UNITED STATES PATENT AND TRADEMARK OFFICE

Office Action Summary

10/800,700

DETAILED ACTION

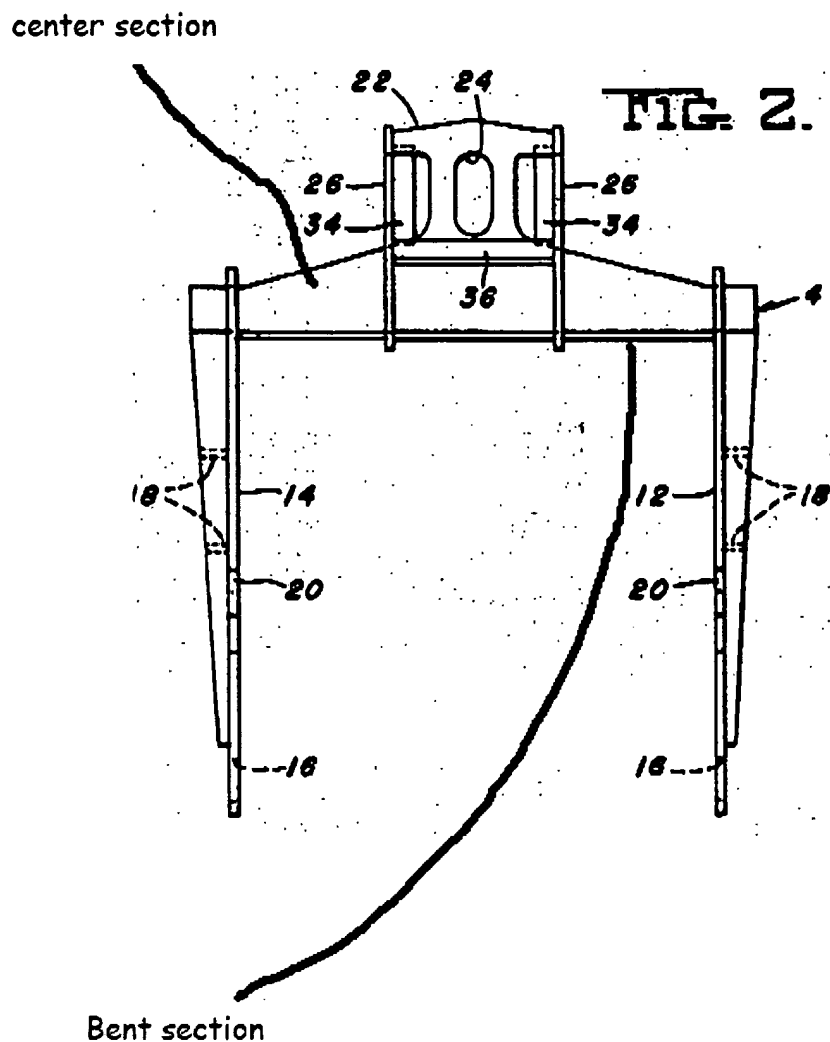
Feczko teaches a sling fitting (4) which is rotatably connected to an object to be lifted, which is conventional and known within the art. (Col 2, lines 34-46)

Regarding claim 2, Feczko discloses a stopper (8), which stops the rotation of the sling fitting in a near vertical direction.

Regarding claim 4, the sling fitting of Feczko has a bent section (see figure below) which extends at a right angle to the bottom edge of a center section, and bent sections (12 and 14 are bent with respect to the center section) which are approximately C shaped in plan view (Fig 2) provided near both ends of the sling fitting.
